ADDENDUM CC-2

February 2, 2012

PLAYER DEVELOPMENT AREA - UNIVERSITY OF OREGON
CONFORM SET:
Drawings and Specifications for Combined Contract (CC) Dated January 12, 2012

NOTE:
THIS PLAN SHOWS PLACEMENT OF EXISTING IRRIGATION LINES BY OTHERS. ACQUIRE AS-BUILTS FOR IRRIGATION LINES FROM OWNER BEFORE INSTALLING NEW UTILITY LINES AND CONDUITS AS SHOWN ON CIVIL AND ELECTRICAL PLANS. ENSURE THAT EXISTING IRRIGATION LINES REMAIN IN PLACE AND UNDISTURBED.

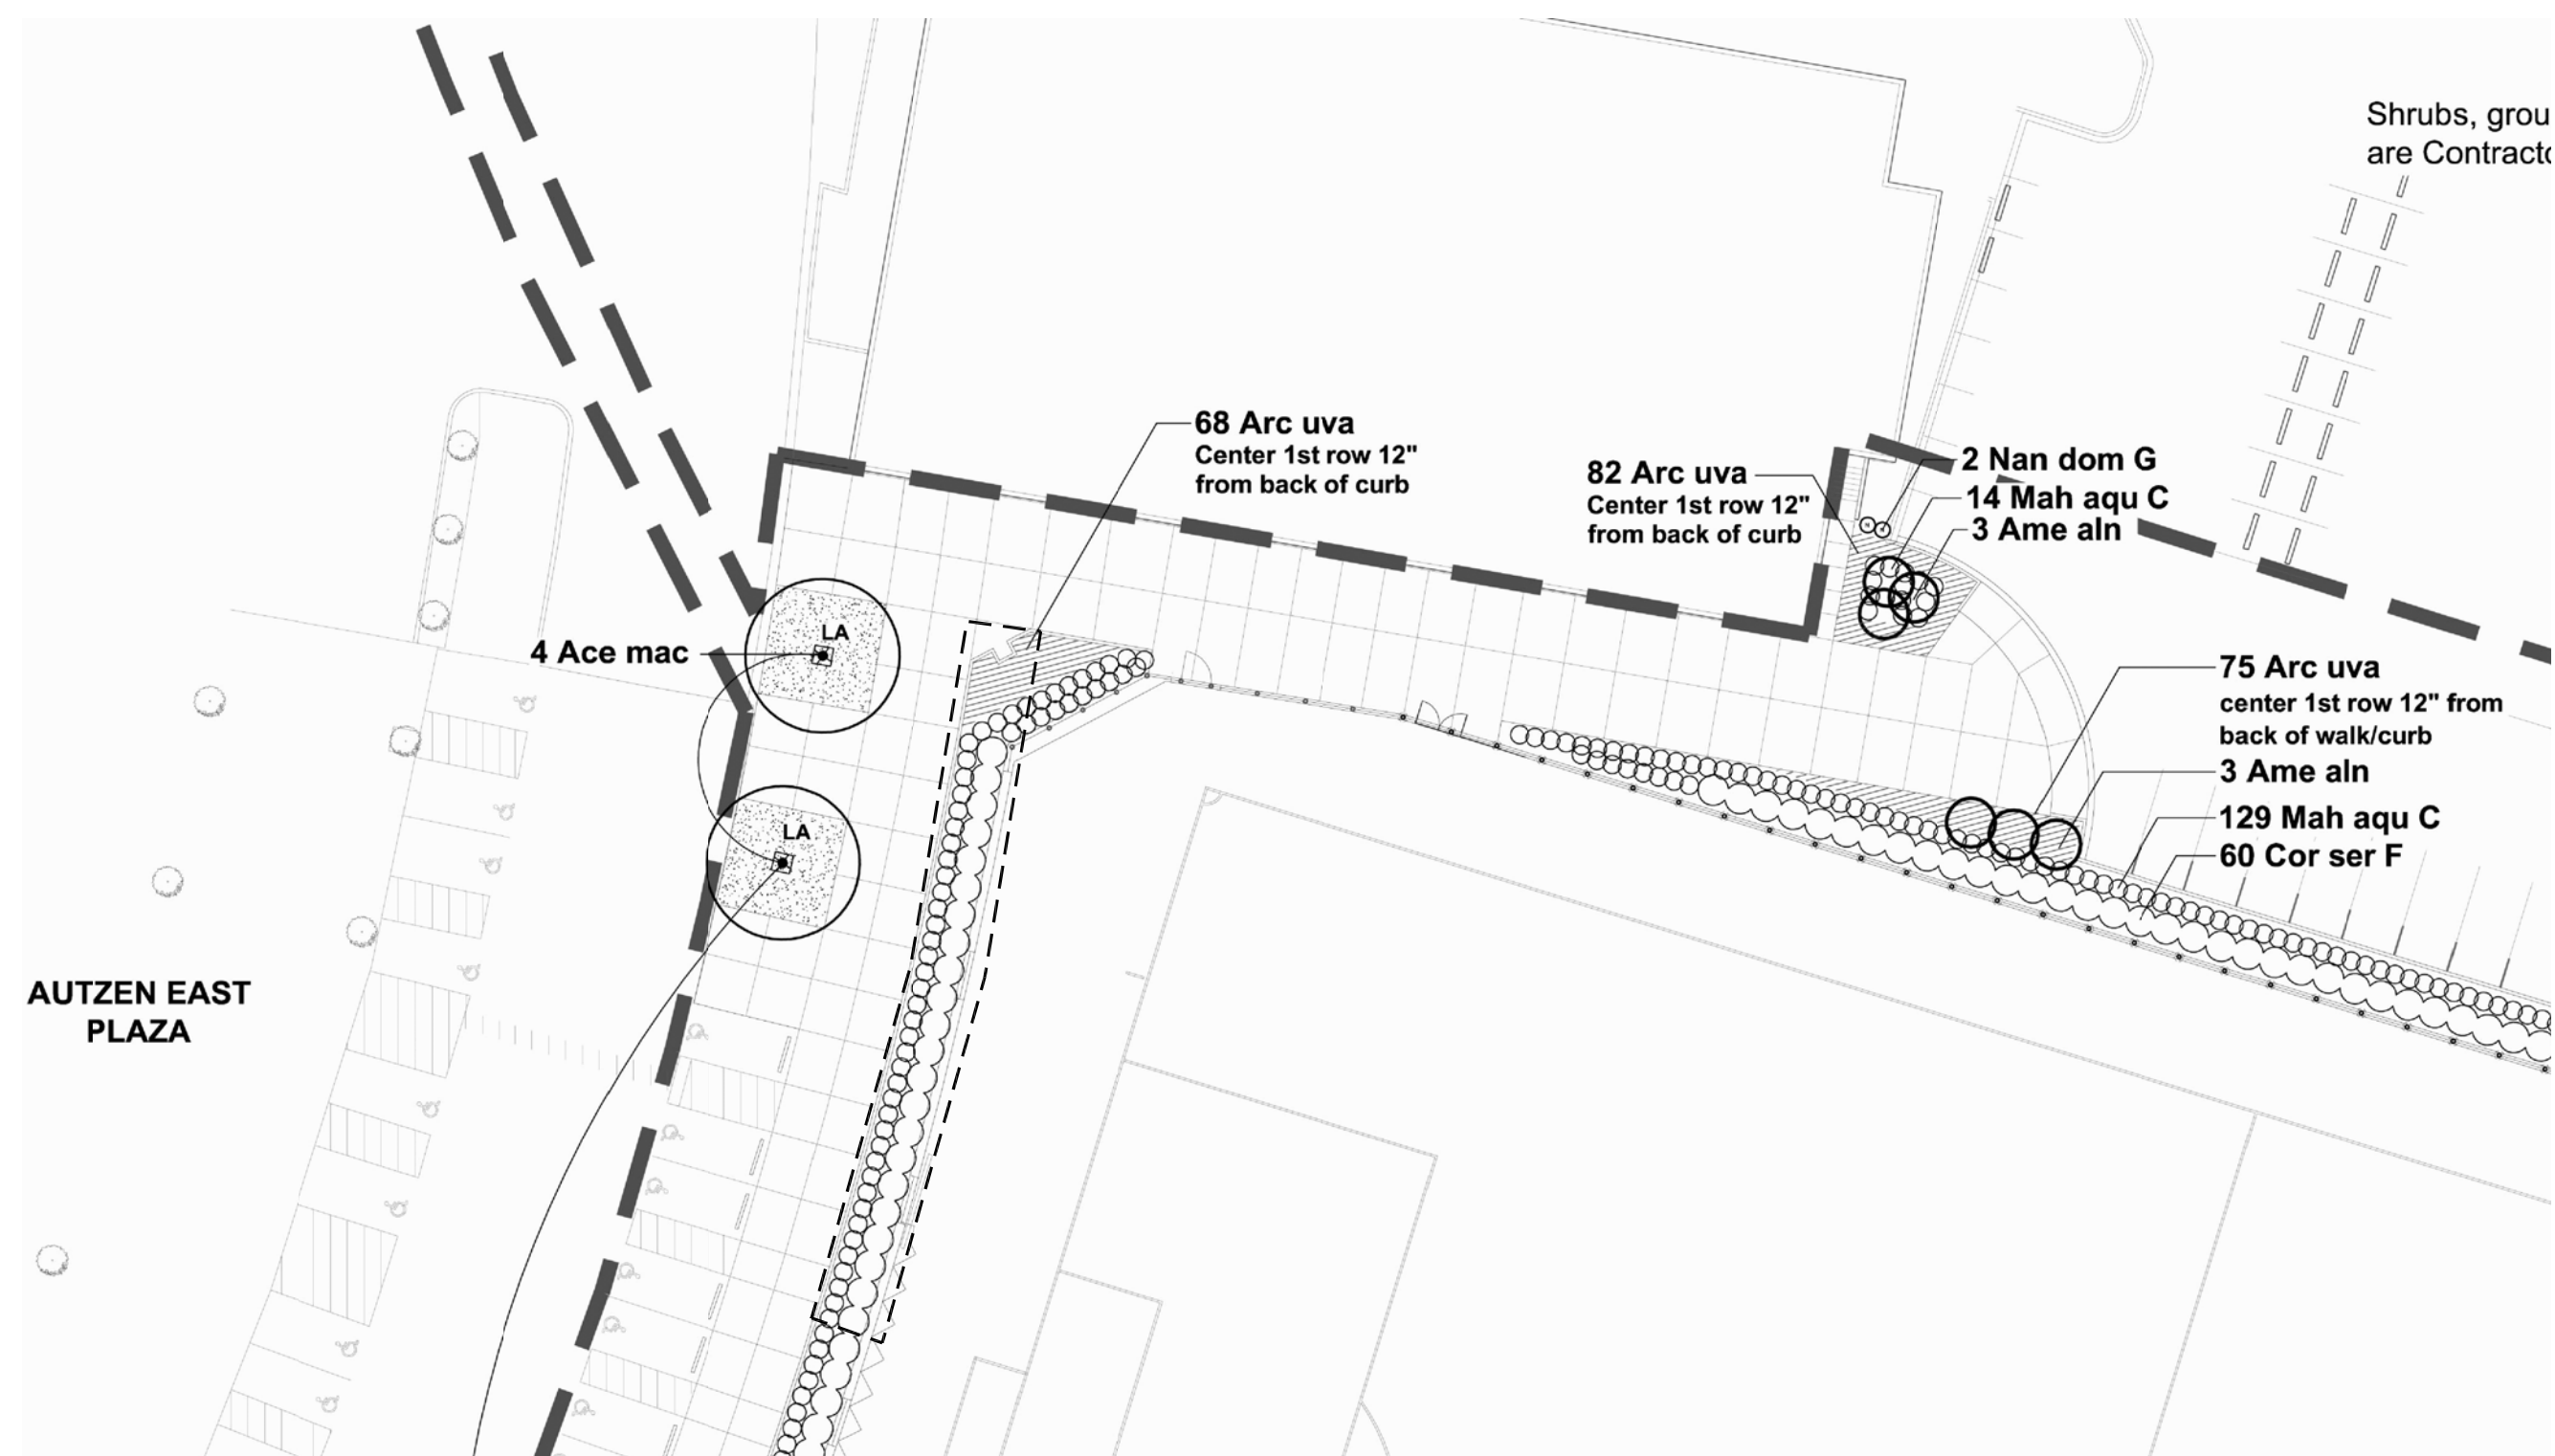
- A. Add new paragraph 3.1.D as follows:
 - D. Alternate No. 4:
 - 1. New paving and landscape modifications to the south of the Player Development Area building. See drawings AS1.1 and AS1.2 added by Addendum CC-2 dated February 2, 2012.

ITEM NO. 49 DRAWING AS1.1 - SITE PLANS - ALTERNATE 4

4 SECTION: PERIMETER WALL
 L12 Scale 3/4" = 1'-0"

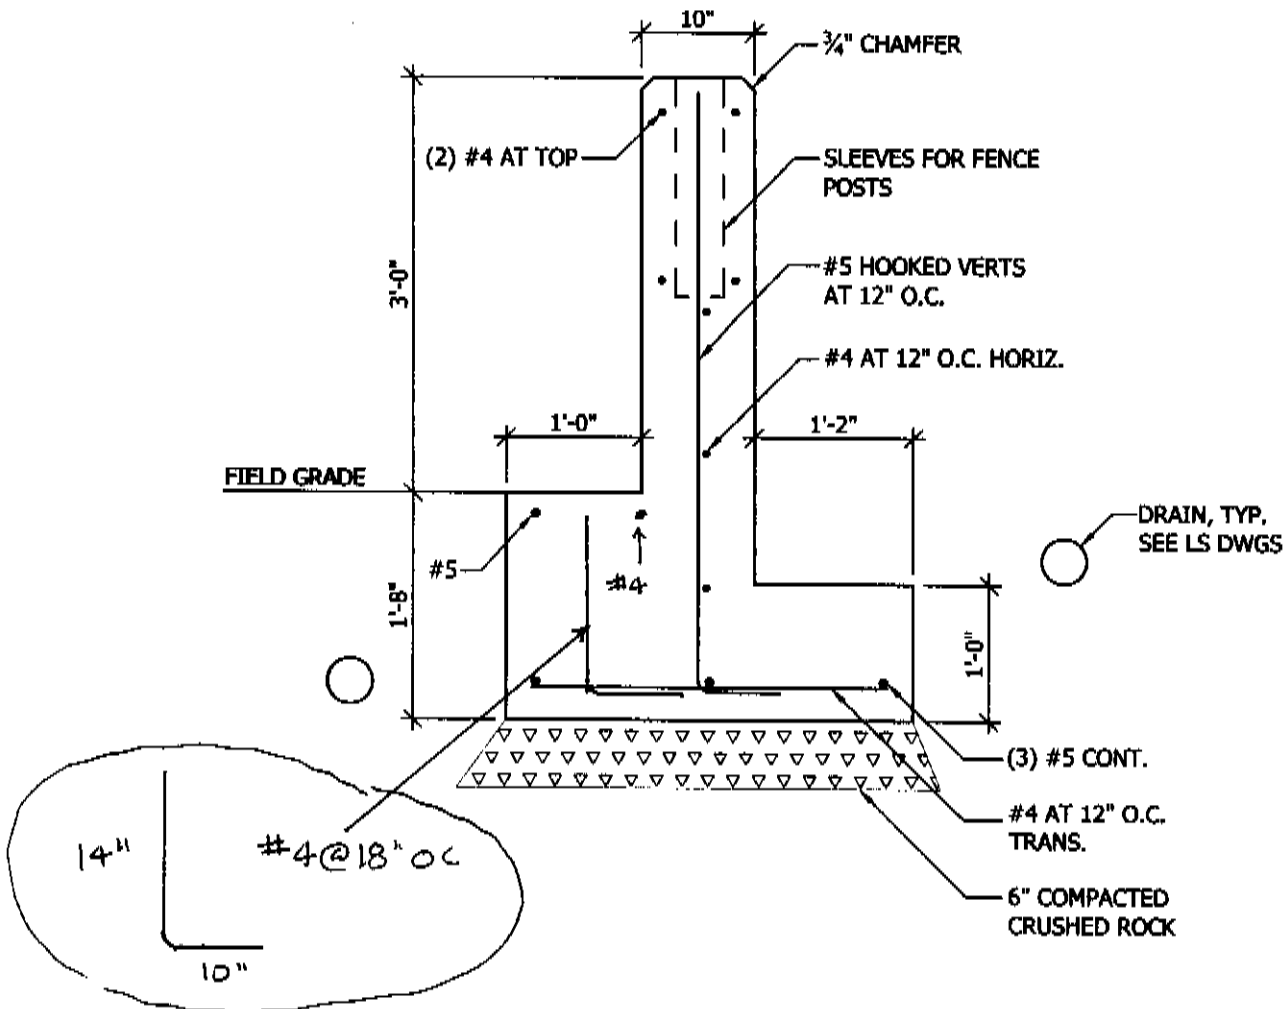
The existing wall along GL 6 will need to be cut out at the (5) new footing locations. What I was trying to figure out is the height of that wall and if there is a footing that will need to be saw cut out of there in addition to the wall. The note on S1.1 says to provide rebar dowels between the old and new construction, but doesn't specify size and spacing. If a detail could be provide in the addendum that would be great?

ITEM NO. 51 DRAWING S1.1 - FOUNDATION PLAN

Answer: The Contractor shall reconstruct the wall as it exists and to provide rebar dowels for each of the bars shown that are interrupted, embedded 3 ½" into the existing concrete with epoxy adhesive. See section for the baseball park perimeter walls as shown in **Attachment S-1** to this Addendum.

Attachment No. E1
to ADD-2
Dated: February 2, 2012

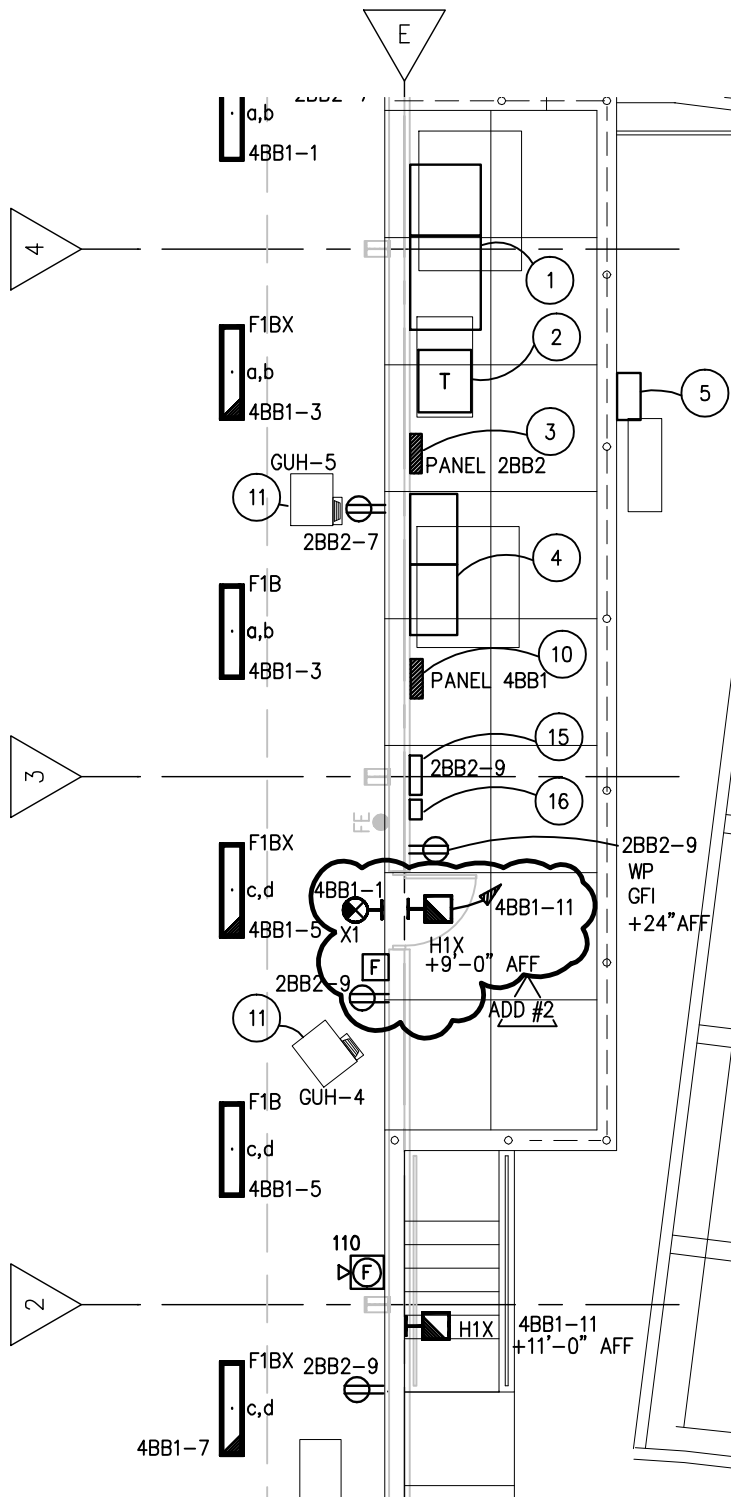
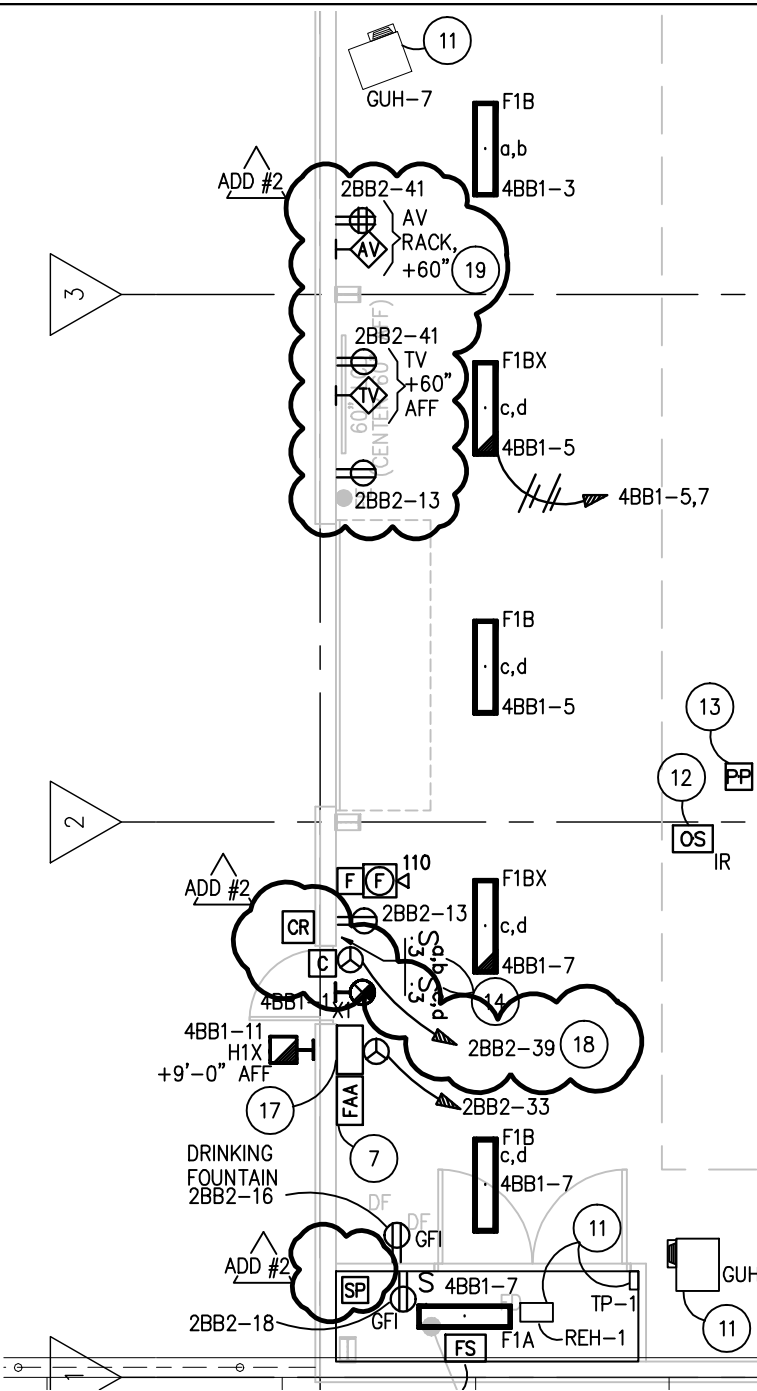
- A. Add exit sign above door for new exterior door as shown on **Attachment E1**.
- B. Add fire alarm manual pull station next to new exterior door as shown on **Attachment E1**.
- C. Relocate exterior wall pack H1X above new exterior door as shown on **Attachment E1**.
- D. Align fixtures in Bull Pen as shown on **Attachment E2**.
- E. Delete door contacts for door 100.
- F. Replace key pad for door 100A with stand alone card reader system: Honeywell Indala Series Model #FP610/710/810 Flex Pass mid-range. Revise note 18 as shown on **Attachment E3**.

- 18 PROVIDE DEDICATED 20A, 120V POWER CIRCUIT TO DOOR CONTROL. SEE ACCESS CONTROL DETAIL FOR CONDUITS REQUIREMENTS. ADD #2
- 19 PROVIDE ALL CONDUITS/PATHWAYS, WIRING/CABLING, DEVICES AND DEVICE BOXES FOR AV EQUIPMENT, TV AND SPEAKERS FOR A COMPLETE SYSTEM PER SPECIFICATION 272250 AND MANUFACTURERS RECOMMENDATION. ALL WIRING/SYSTEM CABLING SHALL BE CONCEALED AND TERMINATED AT A DEVICE BOX PROVIDED WITH APPROPRIATE TERMINATION CONNECTIONS (HDMI, S-VIDEO, RCA, F-CONNECTORS, ETC) AND MATCHING FACEPLATE(S) AS REQUIRED. SPEAKERS (NOT SHOWN) SHALL BE LOCATED AT SHELVES IN THE CORNERS OF THE ROOM (+96" AFF) PER ARCHITECTURAL. COORDINATE ALL DEVICE BOX REQUIREMENTS AND RACEWAY ROUTING WITH ARCHITECT PRIOR TO ROUGH-IN.

ACCESS CONTROL DETAIL
SCALE: NO SCALE

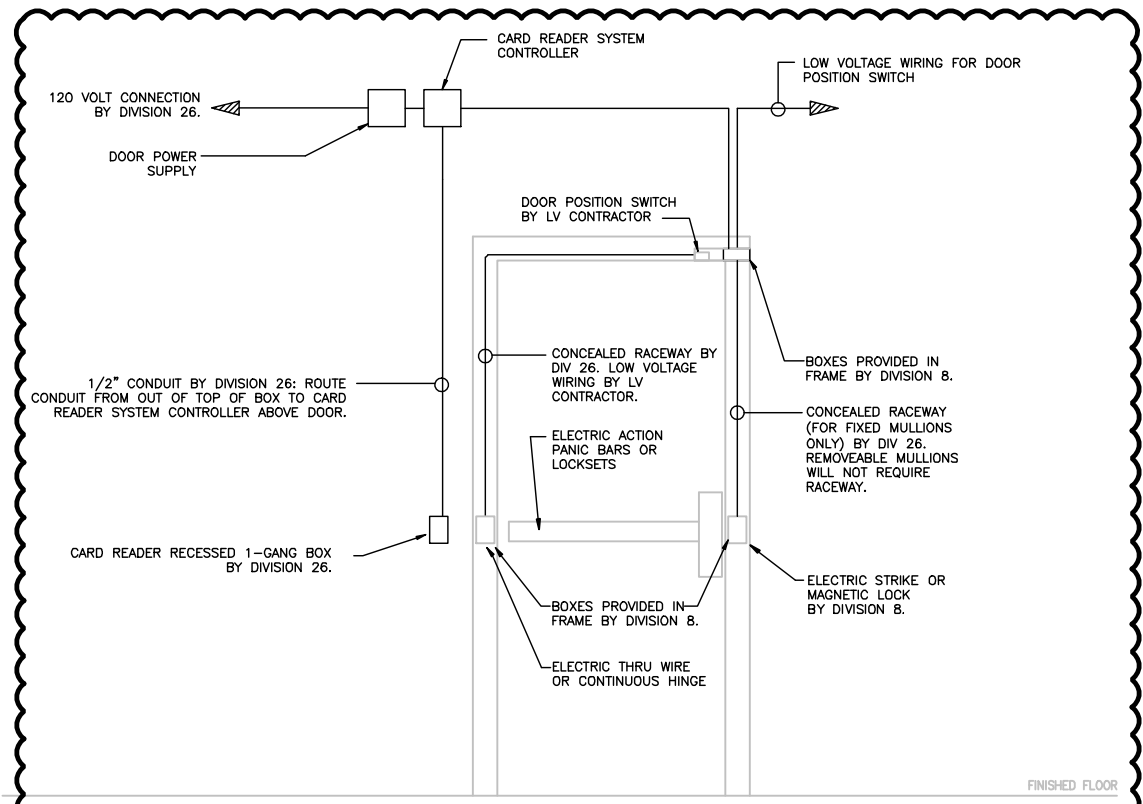
- G. Provide duplex receptacle and AV outlet for Plasma Monitor @ +60" AFF as shown as shown on **Attachment E3**.
- H. Provide quad receptacle for AV rack as shown on **Attachment E1**. Add note 19 as shown on Attachment E3.
- I. (3) speakers will be supported by corner shelves as shown on Architectural plan A1.1 and (1) speaker (symbol SP) will be located above fire riser room as shown on **Attachment E3**.
- J. Add access control detail as shown on **Attachment E4**.

1. CONDUITS AND BOXES INDICATED WITHIN FRAMES APPLY TO HOLLOW METAL DOORS ONLY.
2. DOOR HARDWARE CONFIGURATIONS WILL VARY. ILLUSTRATION IS A GENERAL REPRESENTATION OF CONDITIONS. REFER TO DIVISION 8 DOOR HARDWARE SETS FOR INDIVIDUAL HARDWARE REQUIREMENTS.
3. DIVISION 26: PROVIDE ALL ROUGH-IN (BOTH LINE AND LOW VOLTAGE) AND LINE VOLTAGE CONNECTIONS AT ALL COMPONENT LOCATIONS FOR A COMPLETE AND OPERATIONAL SYSTEM.
4. INSTALLATION MEANS AND METHODS WILL VARY DEPENDING ON DOOR CONFIGURATIONS. CONCEAL ALL CARD READER ROUGH-IN BOXES, CONDUITS TO BOXES, CONDUITS TO DOOR HARDWARE AND FRAMES, AND CONDUITS TO/FROM POWER SUPPLIES (AND CARD READER MODULES) IN WALLS AND CEILINGS. EXPOSED RACEWAY IN NEW CONSTRUCTION IS UNACCEPTABLE.
